1. Viewpack

44 FAIR ST- HARDSCAPE- FENCE OB SUB FOR 7-13-20.PDF  
15 BROAD ST- HARDSCAPE- OB SUB FOR 7-13-20.PDF  
58 WALSH ST- NEW DWELLING-OB SUB FOR 7-13-20.PDF  
12 LINCOLN AV- REV 73364-RE-SITE POOL-OB SUB FOR 7-13-20-ADDITIONAL  
INFORMAITON.PDF  
19 LILY ST- HARDSCAPE- SUB FOR OB 7-13-20.PDF

4.	Teal Sziklas 06-1263	44 Fair Street	Hardscape – fence	42.3.2-155	Linda Williams
Voting	Pohl, Coombs, Camp, Oliver, Welch				
Alternates					
Recused					
Documentation	Landscape design plans, site plan, photos, and advisory comments.				
Representing	Linda Williams				
Public					
Concerns (5:55)	<p><b>Williams</b> – Presented project; HSAB asked the fence slope down then the gate step down rather than step the fence. There's substantial plantings along part of the front.</p> <p><b>Backus</b> – Read HSAB comments: want the fence sloping with the gate squared off; have no drawings.</p> <p><b>Welch</b> – A consideration is the grade behind the fence; if there's something at the bottom to hide the grade, it could all be 36". We need a drawing to indicate what will be there. The 1880 photo shows a small return that gives a sense of entry.</p> <p><b>Coombs</b> – Thinks we should view thi

1 NORTH ELEVATION  
SCALE: 1/4" = 1'-0"

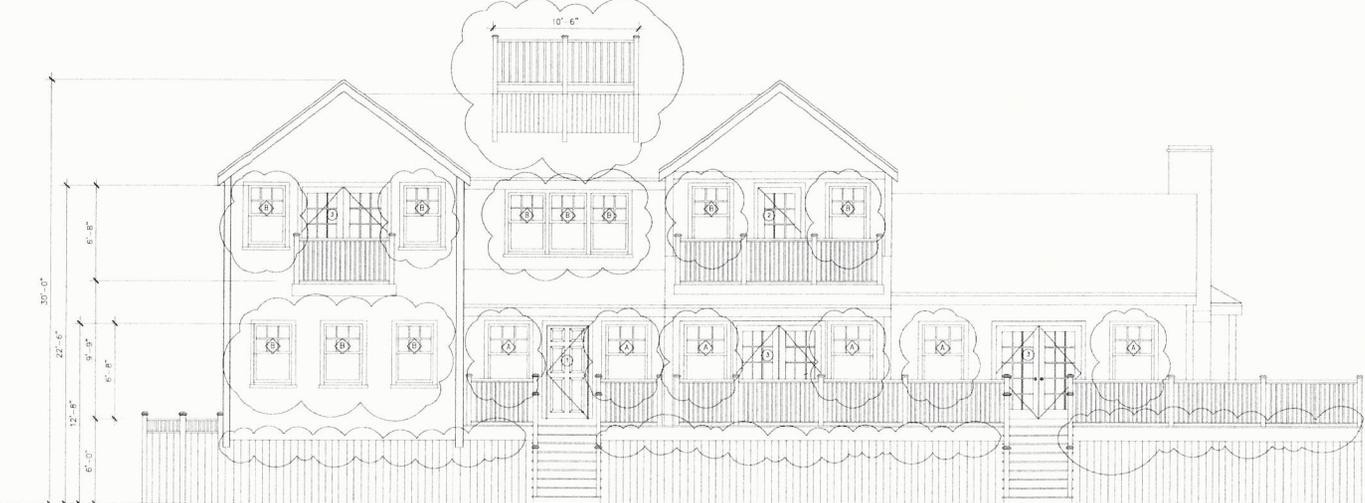
**Coombs** – North elevation, way too many windows; left 4-ganged is too heavy; number of windows should be reduced. Feels this architecture doesn’t call for a roof walk. South elevation, right windows in gable should be separated; windows not centered. The chimneys need corbelling. East elevation is better, but windows are not centered. West elevation, right gable windows should be separated; the chimney is overly wide, and the outdoor fireplace should be drawn in.

**McLaughlin** – North elevation, the 2-panel door should be a typical 6-panel door.  
    **Camp** – North elevation, this looks like a condo in a complex; the gables forward should be less vertical looking; section over the front door, if those windows were ganged it would be a throwback to shingle style. South elevation, there is no symmetry to the windows, which should align over the 1<sup>st</sup> floor.

Motion                      **Motion to Hold for revisions. (Camp)**
